Memo

Agenda Item: Authorize Change Order No. 5 with LaRiviere, Inc. for the Honeysuckle Avenue and Ramsey Road Roundabout Project for changes related to private utility delays and conflicts, pedestrian access revisions, a deductive adjustment for water facility testing, a deductive adjustment for resident project representative costs for Saturday work, and a time adjustment to ensure that added contract days fall on working days for a net cost decrease of \$6,108.43 and twelve (12) added contract days.

CONTRACT CHANGE ORDER NO. 5

PROJECT: 41014.14 - HONEYSUCKLE AVENUE AND RAMSEY ROAD
ROUNDBOUT IMPROVEMENTS

Drainage and Landscape Plans, Sheets 21 and 22 of 44

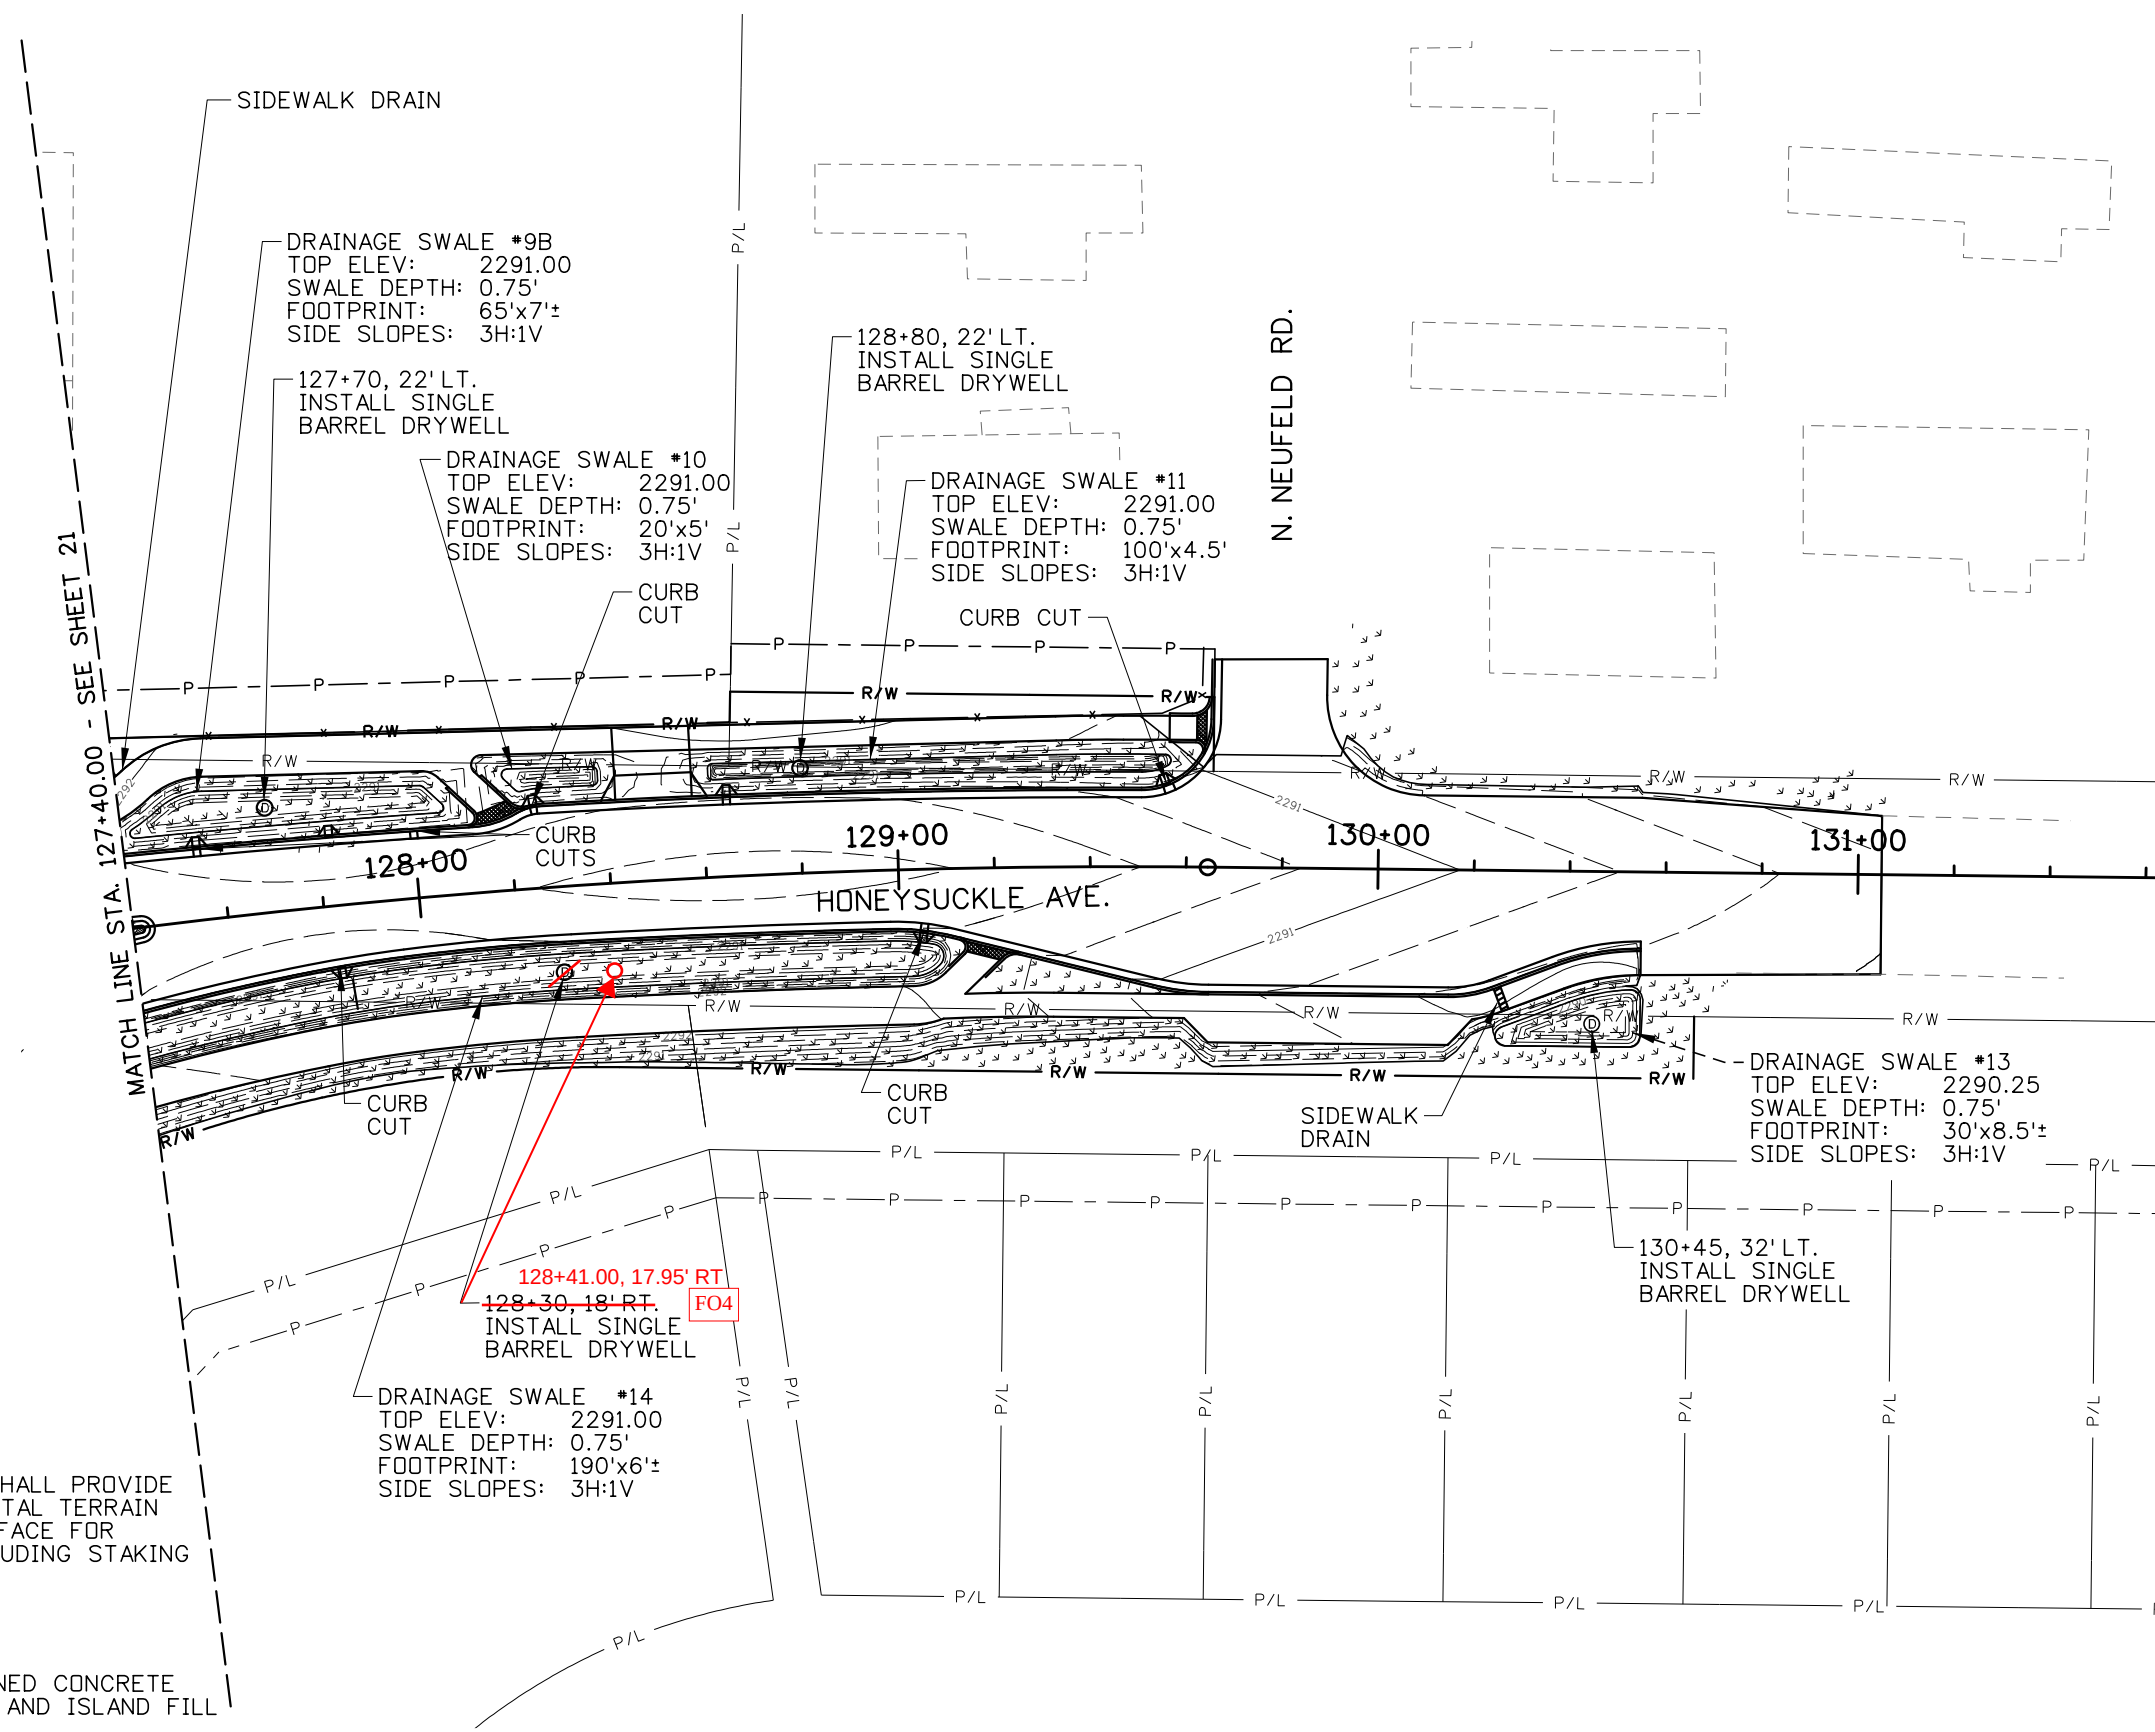
DRAWING # & DETAIL: Roundabout Plan Sheets 21 and 22 of 44
